Please review the soils & geology report checklist for report requirements. A detailed map, drawn to scale, is required for all soils & geology reports. The checklist details the required information to be included on the map.

**GEOTECHNICAL INVESTIGATION
MAYBERRY APARTMENTS AND TOWNHOMES
TRACT K
STATE HIGHWAY 94 AND NEW LOG ROAD
ELLICOTT, COLORADO**

CTL|T Project No. CS19587-125

September 9, 2022

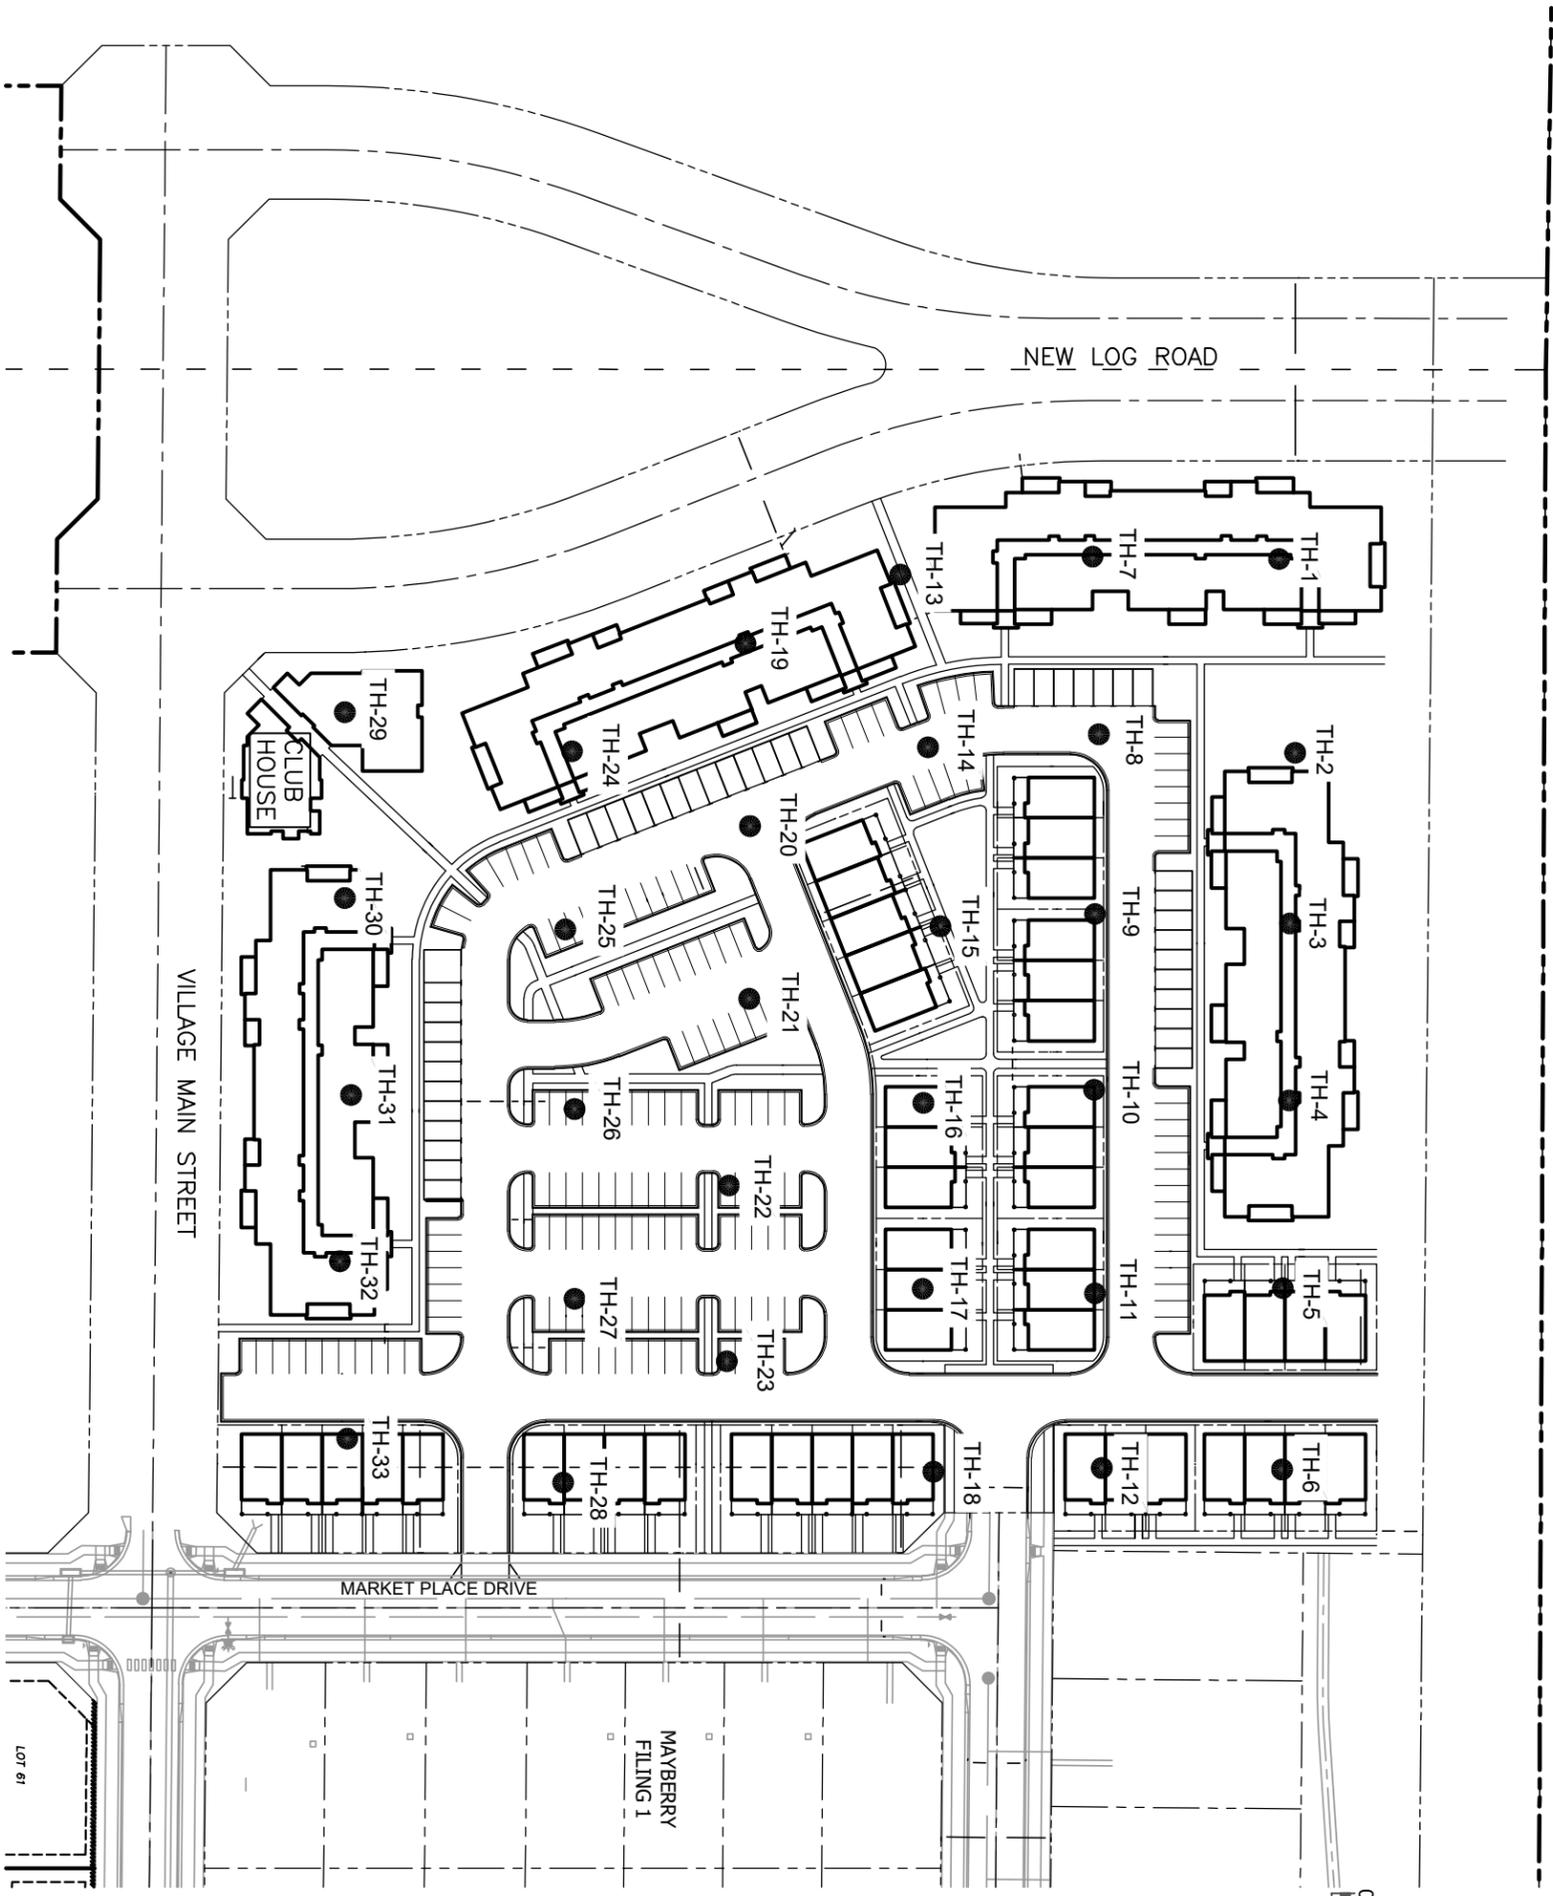
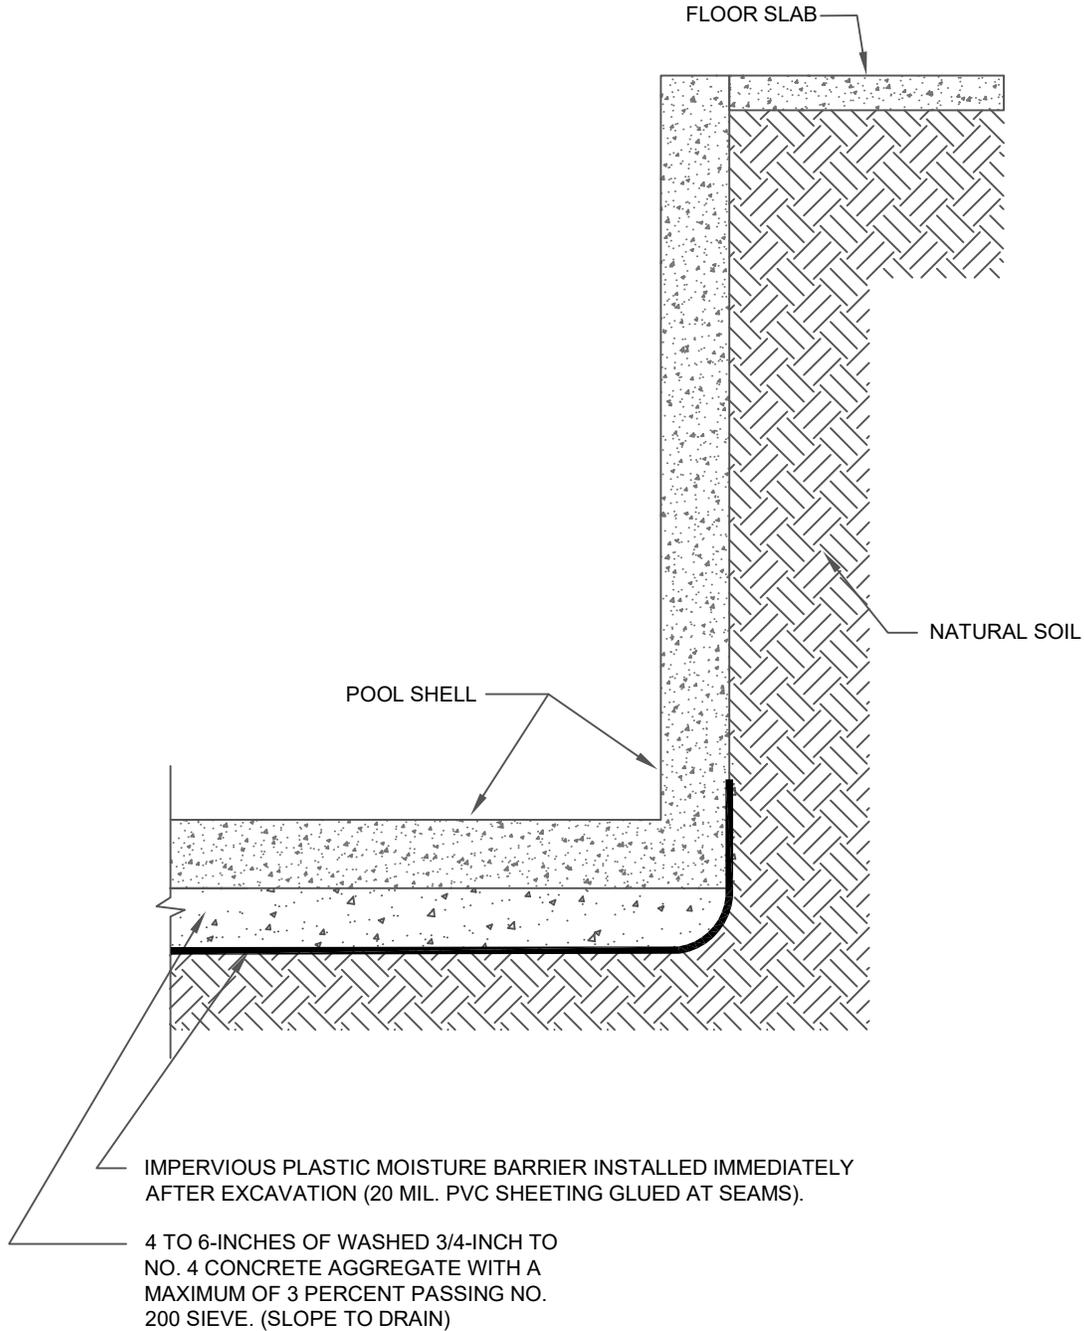
Geologic hazards and constraints need to be identified and shown on the map, and also reflected in the soils & geology note on the PUD plan and depicted on the development plan.
